DATE: October 16, 2023; 10:15 am – 11:15 am

WORK IN PROGRESS: Installation of replacement stone

End of Field Report No. Four

Photo #5: A new sample of patching mortar was available for review and approval.

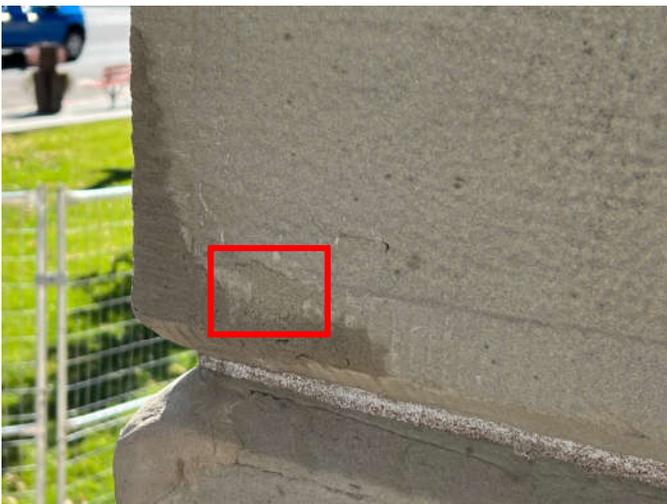
6. A small sample of the Jahn M70 patching mortar to be used at the main entry columns was available for review. It was approved. (See Photo #5.)
7. The repointing of the stone at the south end of the east elevation is mostly completed. The stones at the bottom of the southeast corner will be replaced when the next shipment of stone is delivered. (Re: Photo #6.)
